WESTON UNDER PENYARD

Proposed Access Arrangements

Stage 1 Road Safety Audit

Project: Weston under Penyard
Proposed Access Arrangements

Location Plan(s)

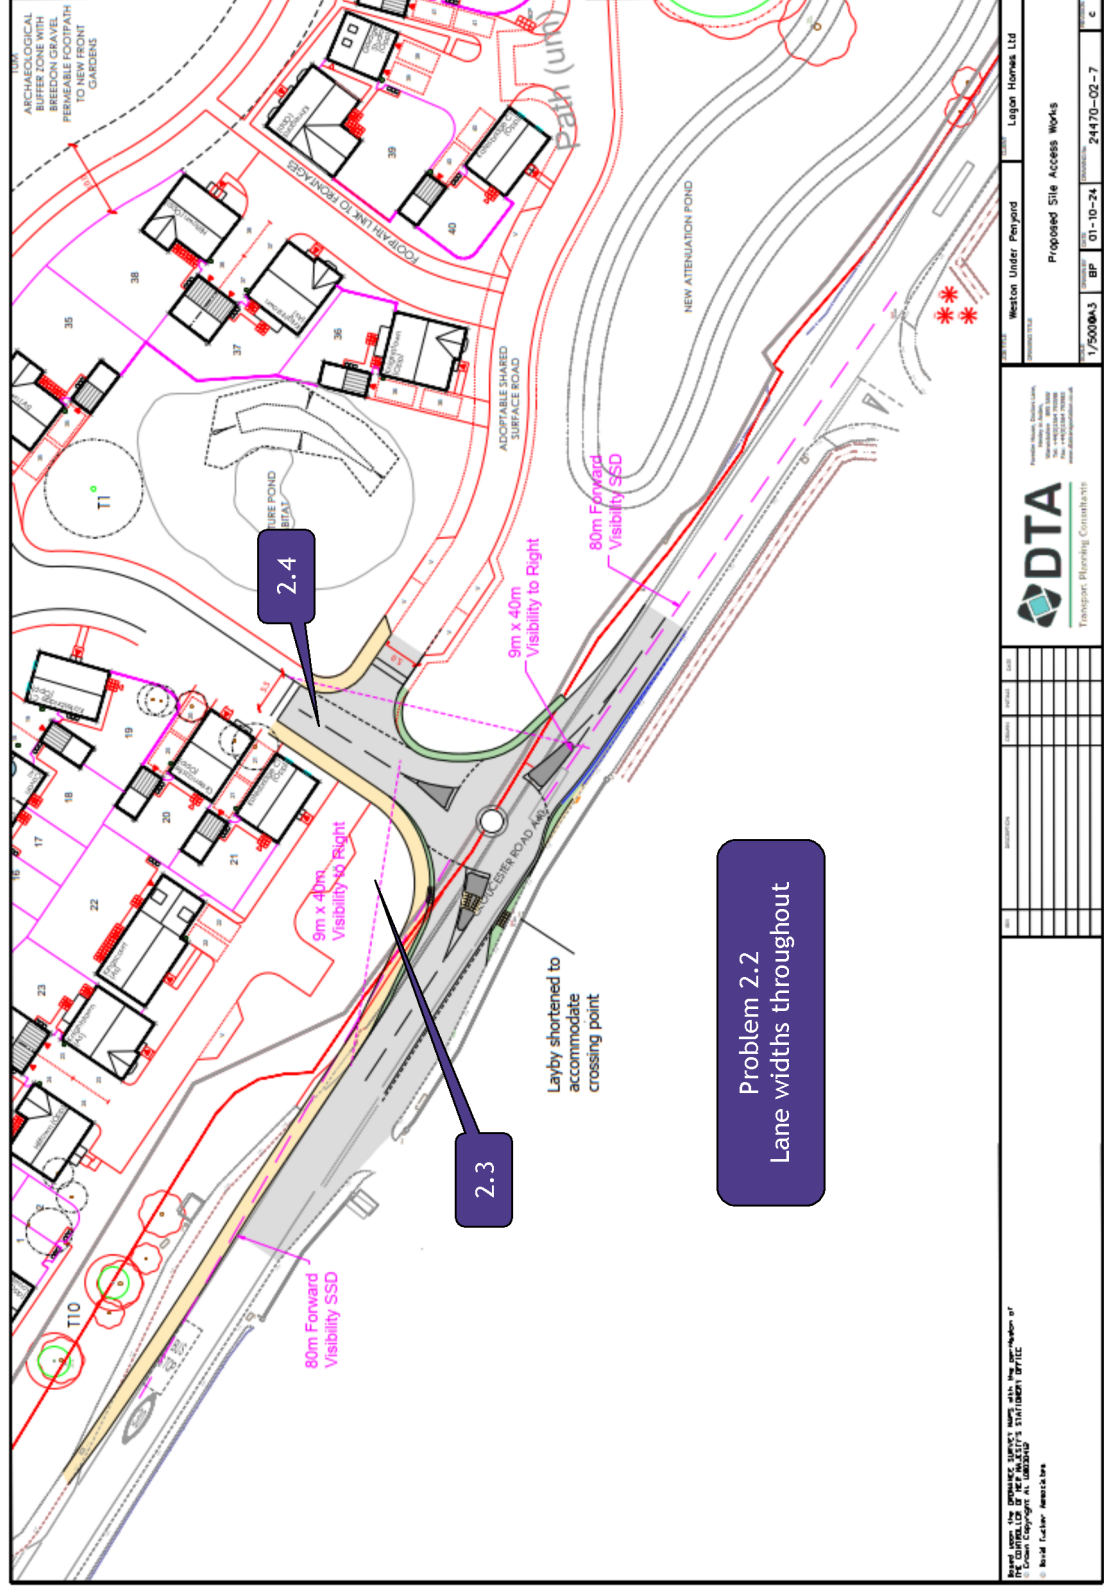
Insufficient lane widths may result in cyclist collisions

Location: approaches to mini roundabout

Proposed carriageway widths adjacent to the islands at the mini roundabout have not been indicated. Lane widths of between 3.2m and 3.9m are not acceptable for cycling in mixed traffic. (LTN 1/20 Table 7-2), and the audit team is concerned that insufficient lane widths may result in cyclists being struck.

Suitable lane widths should be provided.

Restricted visibility may result in turning collisions

Location: development arm of mini roundabout

Visibility splays to and from the development arm of the proposed mini roundabout have not been indicated. Proposed landscaping and boundary treatments may obscure drivers' visibility when turning out of the development, resulting in collisions at the roundabout.

Landscaping and planting should be of a low level variety and boundary treatments should be located at the rear of the visibility splay.

Pedestrians crossing the development arm may be struck by a passing vehicle.

Location: development arm of mini roundabout

Dropped crossing points on Gloucester Road are proposed for pedestrians to access the bus stops, however the internal road has no facility to cross west to east which may result in pedestrians crossing at unsafe locations and being struck by a passing vehicle.

A dropped crossing facility should be provided across the development access arm of the mini roundabout for pedestrians accessing the bus stops.

RSA Decision Log				
Item No.	RSA Recommendation	Design Organisation Response	Overseeing Organisation Comments	Agreed RSA Action
2.2	Suitable lane widths should be provided.	The Recommendation is acknowledged. The lane widths on the on approach to and exit from the mini roundabout will be narrowed to 3.2m with white line hatching.	The westbound nearside lateral shift is not required in this context and should be removed. The central splitter area should be enlarged but should be over-runable.	The approach lane and exit will be narrowed to 3.2m. The nearside lateral shift will not be provided. An over-runable arm splitter area will be provided. These are indicatively shown on DTA Drawing 24470-02-07.

2.3	Landscaping and planting should be of a low-level variety and boundary treatments should be located at the rear of the visibility splay.	The Recommendation is agreed and is to be respected at the implementation stage.	-	Landscaping and boundary treatments will not encroach in the junction visibility envelope.

2.4	A dropped crossing facility should be provided across the development access arm of the mini roundabout for pedestrians accessing the bus stops.	A dropped crossing with tactile paving is added to the internal site road providing safe and convenient means to cross from east to west within the site to access the A40 crossing.	-	A crossing will be provided on the access road as indicatively shown on DTA Drawing 24470-02-07
